SUBJECT: NINE MILE POINT NUCLEAR STATION, UNITS 1 AND 2 - STAFF ASSESSMENT OF INFORMATION PROVIDED PURSUANT TO TITLE 10 OF THE *CODE OF FEDERAL REGULATIONS* PART 50, SECTION 50.54(f), SEISMIC HAZARD REEVALUATIONS FOR RECOMMENDATION 2.1 OF THE NEAR-TERM TASK FORCE REVIEW OF INSIGHTS FROM THE FUKUSHIMA DAI-ICHI ACCIDENT (TAC NOS. MF3973 and MF3974)

STAFF ASSESSMENT BY THE OFFICE OF NUCLEAR REACTOR REGULATION
RELATED TO SEISMIC HAZARD AND SCREENING REPORT
NINE MILE POINT NUCLEAR STATION, UNITS 1 AND 2
DOCKET NOS. 50-220 AND 50-410

Figure 3.3-1 Plot of Staff's and Licensee's Base Case Shear-Wave Velocity Profiles for the NMP site

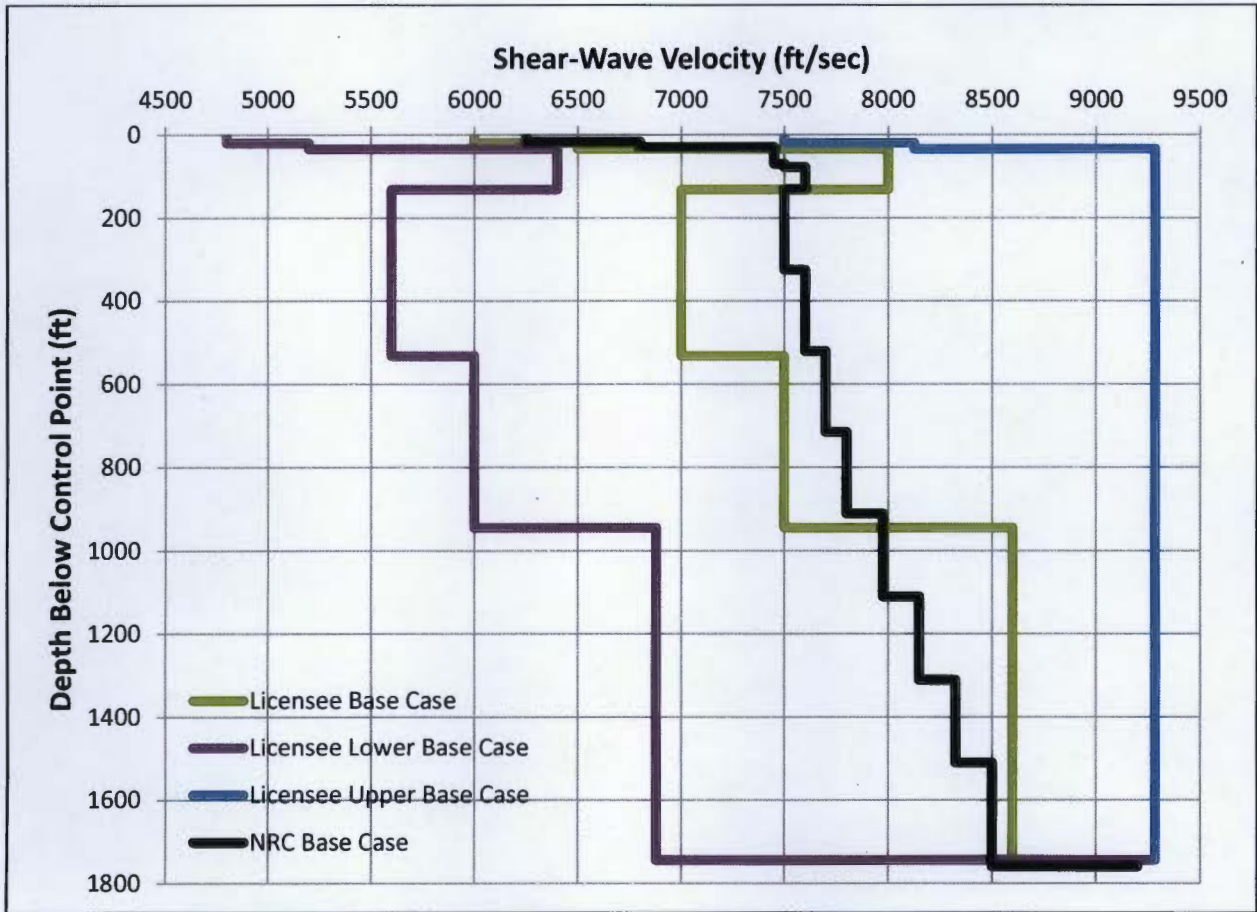
To characterize the subsurface geology, the licensee developed three site base case profiles. The middle, or best estimate, profile was developed using measured shear-wave velocity from nearby cross-hole geophysical investigations. The licensee determined the shear wave velocities for the upper 325 ft [99 m] of rock from measurements near NMP Unit 2, and it determined the velocities for the deeper rock units from measurements at the proposed NMP Unit 3. Upper and lower base case profiles were developed using a natural log standard deviation of 0.18. Figure 3.3-1 of this assessment shows the licensee's three shear-wave velocity base case profiles.

Because the site is well characterized and the velocities reported in the NMP Unit 2 FSAR (Constellation, 2012) and the proposed NMP Unit 3 SAR (UniStar, 2009) are similar, the staff used only a single shear wave velocity profile rather than the three profiles used by the licensee. For the depth interval between the control point and 200 ft [61 m] below the control point, the staff used an average of the measured shear wave velocities at NMP Unit 2 and the proposed NMP Unit 3 for its shear wave velocity profile. For depths between 200 ft [61 m] below the control point and the base of the profile, the staff used the shear wave velocities from the proposed NMP Unit 3. To capture the uncertainty in the depth to base rock, the staff used a value of ± 150 ft [± 46 m], which is considerably less than the ± 524 ft (± 160 m) depth to base rock randomization used by the licensee. Figure 3.3.-1 of this assessment shows the staff's velocity profile compared to the base case profiles developed by the licensee.

Figure 3.3-2 Plot Comparing the Staff's and the License's Median Amplification Functions and Uncertainties for two input loading levels for the NMP site

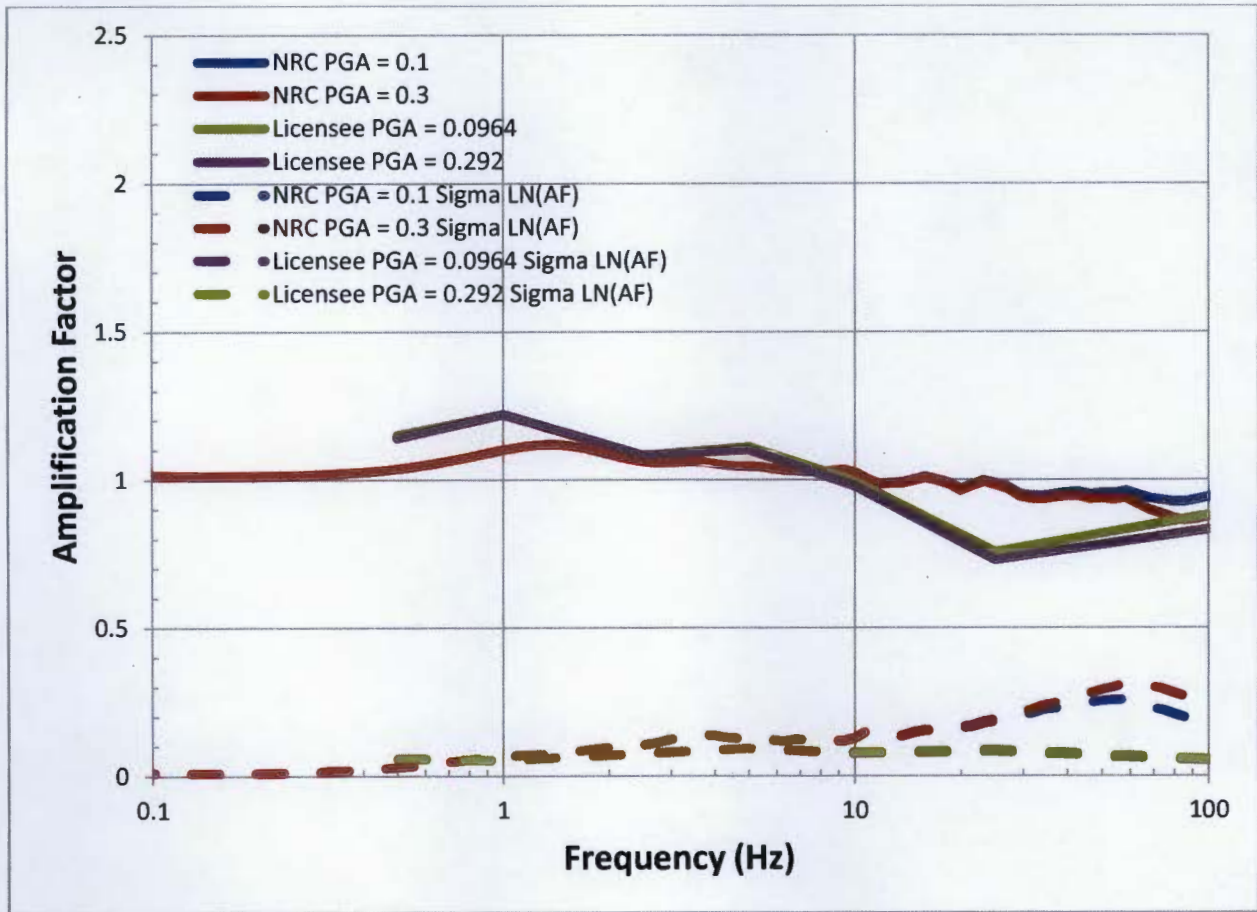
Figure 3.3-2 of this assessment shows a comparison of the staff's and licensee's median site amplification functions and uncertainties (± 1 standard deviation) for two of the eleven input loading levels. Due to the use of very low damping values and modeling of the rock behavior as essentially linear for the range of input loading levels, the staff's confirmatory amplification factors are essentially one for the entire frequency range. Above approximately 10 Hz, amplification functions calculated by the licensee are lower than those developed by the staff due to the greater nonlinearity included in the licensee's analyses.

The staff conducted sensitivity tests to evaluate the licensee's use of (1) multiple base case velocity profiles, (2) higher damping values and the assumption of more nonlinearity over a larger portion of the subsurface profiles, (3) higher kappa values, and (4) a large depth to base rock randomization value. Of these four factors, the higher damping values (3 percent and higher), which the licensee used for the upper 500 ft [152 m] of the rock profile, resulted in the largest difference in the sets of amplification factors developed by the licensee and staff. These differences are shown in Figure 3.3-2 of this assessment for frequencies above 10 Hz.

Figure 3.3-3 Plot Comparing the Staff's and the Licensee's Mean Control Point Hazard Curves at a Variety of Frequencies for the NMP site

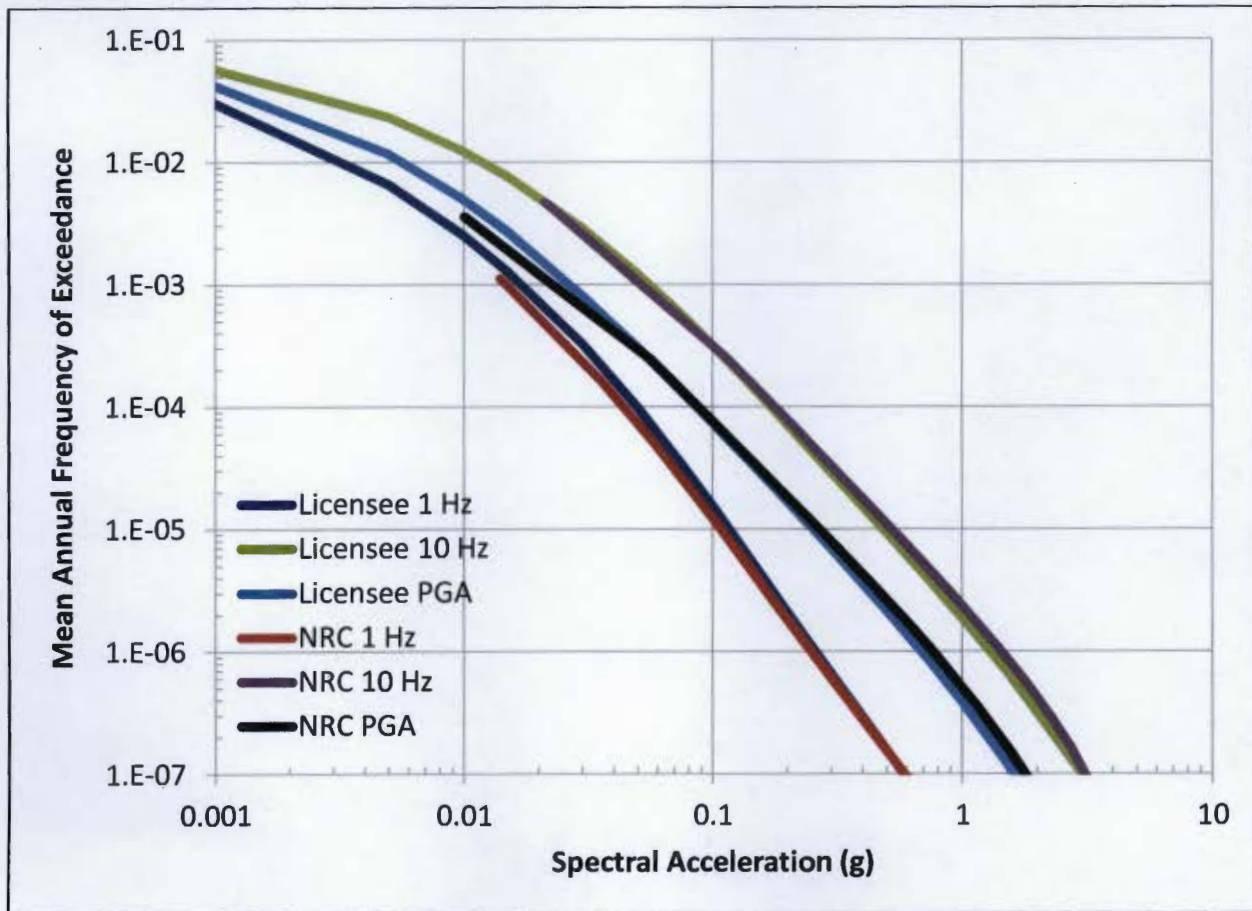
Overall, the licensee’s approach to modeling the subsurface rock properties and their uncertainties results in slightly lower site amplification factors relative to the staff’s results, particularly at high frequencies. However, as shown in Figure 3.3-3 of this assessment, these differences in the site response analysis do not have a large impact on the control point seismic hazard curves or the resulting GMRS, as discussed below. Appendix B of the SPID provides guidance for performing site response analyses, including capturing the uncertainty for sites with less subsurface data; however, the guidance is neither entirely prescriptive nor comprehensive. As such, various approaches in performing site response analyses, including the modeling of uncertainty, are acceptable for this application.

Figure 3.4-1 Comparison of the Staff's GMRS with Licensee's GMRS and the SSEs for NMP Unit 1 (Red) and NMP Unit 2 (Red dashed).

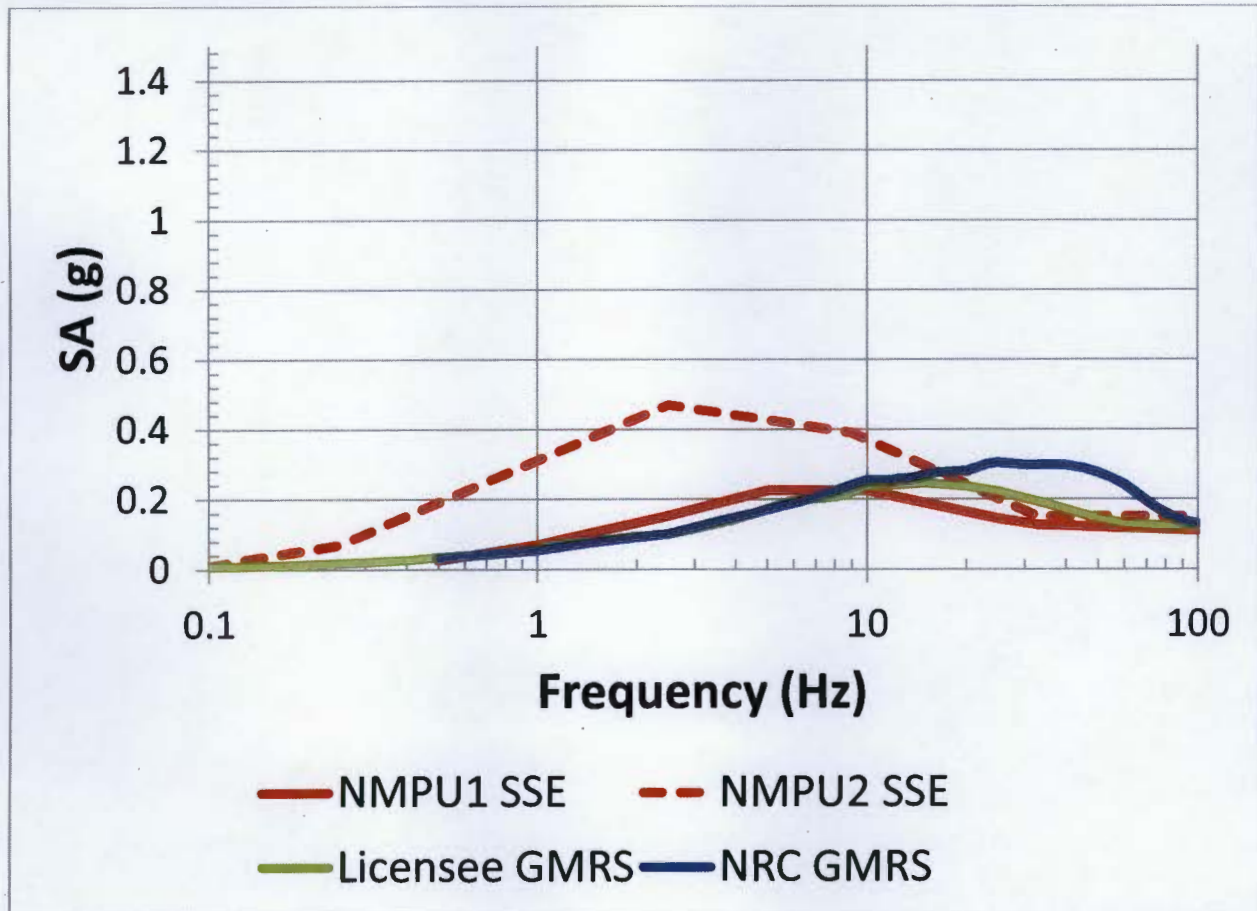
The staff independently calculated the 10^{-4} and 10^{-5} UHRS using the results of its confirmatory PSHA and site response analyses, as described in Sections 3.2 and 3.3 of this staff assessment, respectively. Figure 3.4-1 of the assessment shows a comparison of the GMRS determined by the licensee to that determined by the staff.

As shown in Figure 3.4-1 below, the licensee’s GMRS shape is generally similar to that calculated by the staff at frequencies less than 10 Hz. However, NRC staff’s confirmatory GMRS is somewhat higher than the licensee’s at frequencies above 10 Hz. As described above in Section 3.3, the staff concludes that these minor differences over the higher frequency range are primarily due to the differences in the site response analyses performed by the licensee and staff. The staff concludes that these differences are acceptable for this application because the licensee followed the guidance provided in the SPID with respect to both the PSHA and site response analysis for the NMP site.

The staff confirms that the licensee used the present-day guidance and methodology outlined in RG 1.208 and the SPID to calculate the horizontal GMRS, as requested in the 50.54(f) letter. The staff performed both a PSHA and site response confirmatory analysis and achieved results consistent with the licensee’s horizontal GMRS. As such, the staff concludes that the GMRS determined by the licensee adequately characterizes the reevaluated hazard for the NMP site. Therefore, this GMRS is suitable for use in subsequent evaluations and confirmations, as needed, for the response to the 50.54(f) letter.
